PLAN DETAILED REPORT BBA22-2004 FOR THE CITY OF ANN ARBOR

Description: We did a stair replacement at this property, and the rise and run are off by less than 1 inch. If this was not done, it would have interfered and gone through the window that was already in place

PLAN REVISION/ADDITIONAL INFORMATION

727 E. Kingsley Stair Replacement

2 Typical Tread and Riser Detail
 A-601 4" 8" 1'-4" 1 1/2" = 1'-0"

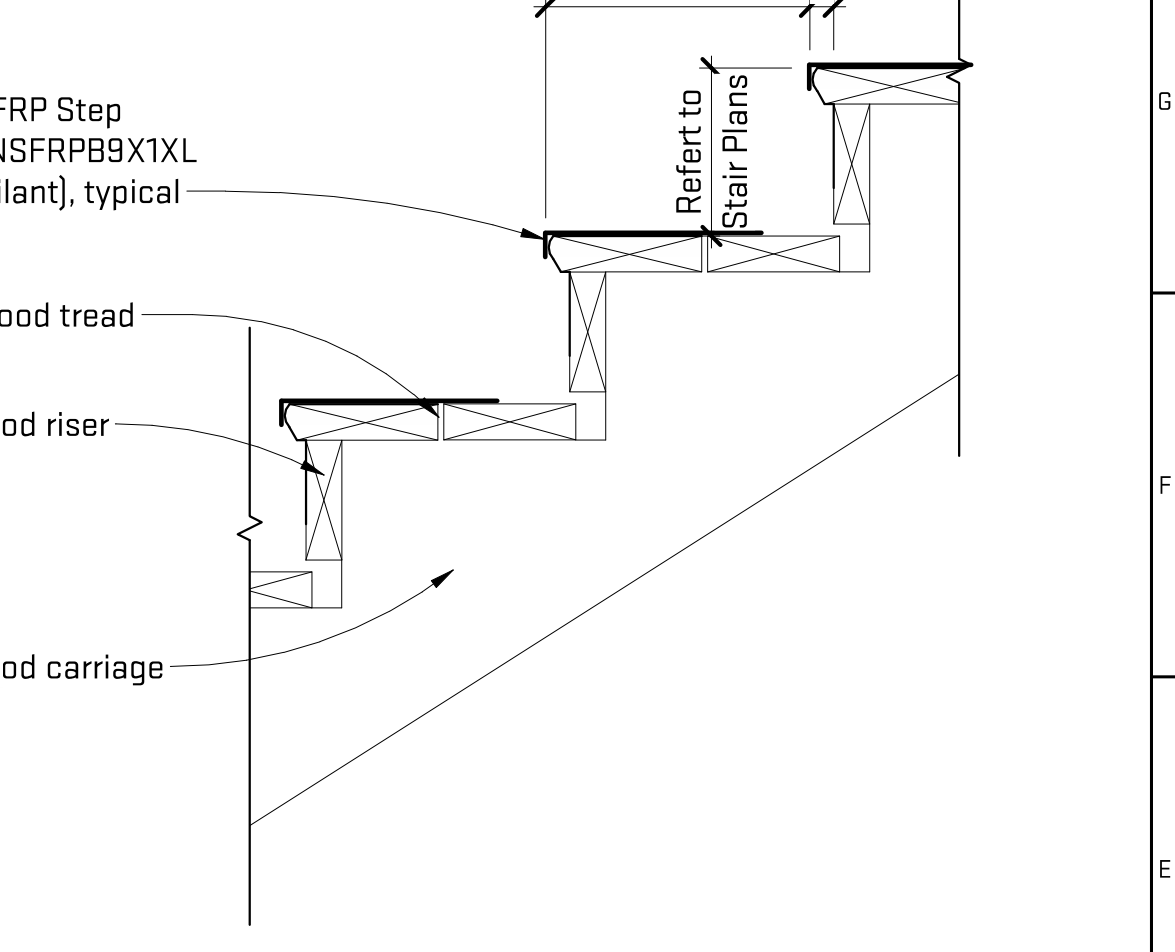
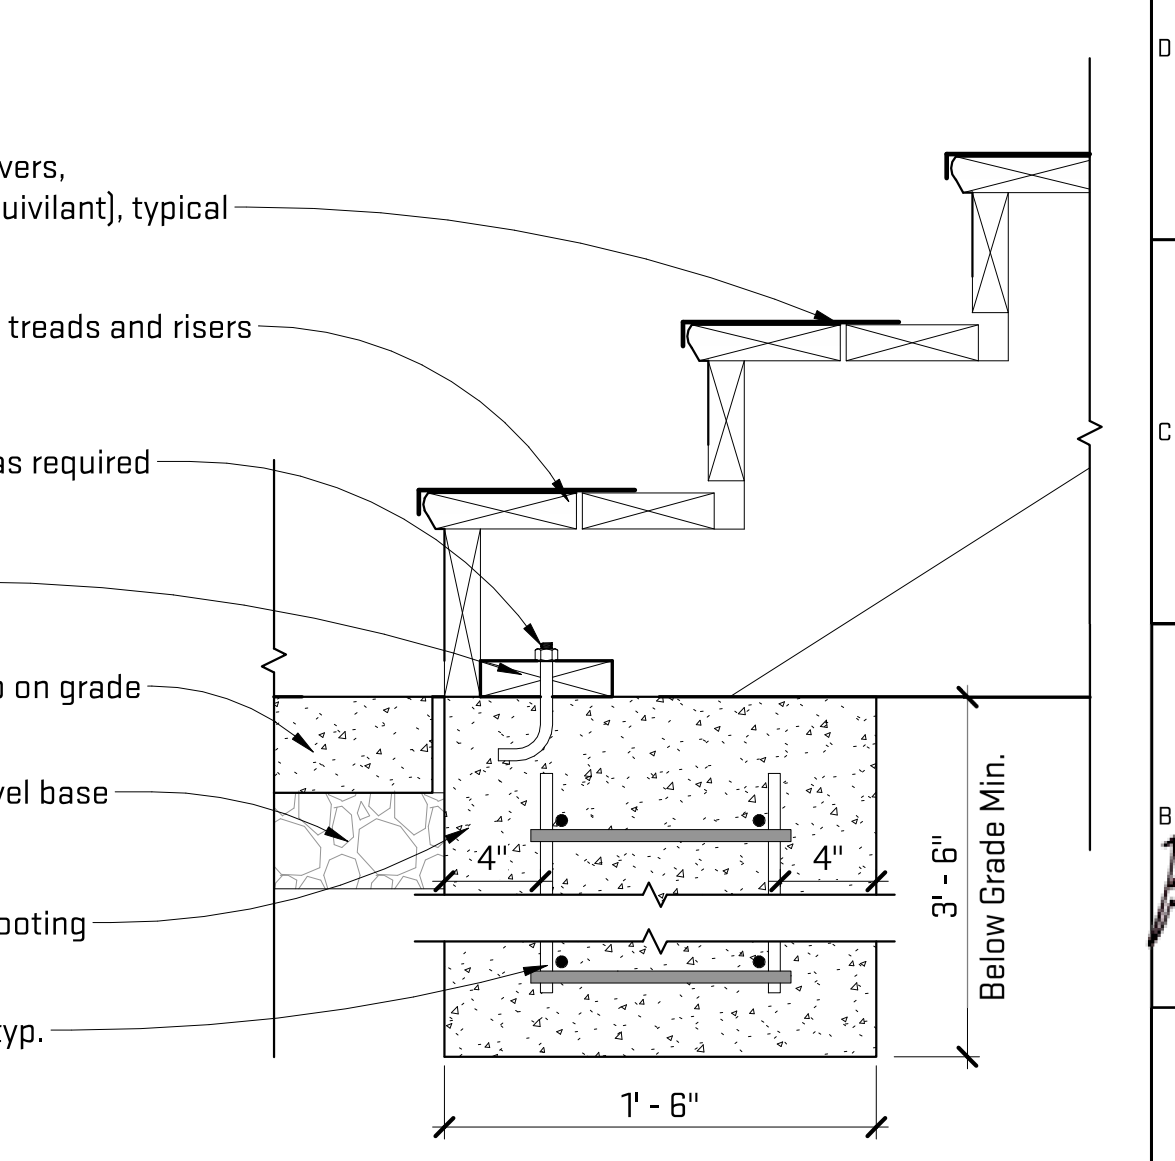
The final inspection was failed due to additional verbage that needed to be on the plans. The plans have been revised to include this verbage as requested by James Worthington

MBC 1011.5.2.3
 Stairs accessory to individual dwelling units in group R-2 occupancies the maximum riser shall be 7 3/4" and the minimum tread depth shall be 10 inches. A nosing projections not less than 3/4" but not more than 1 1/4" shall be provided on stairways with solid risers where the tread depth is less than 11".
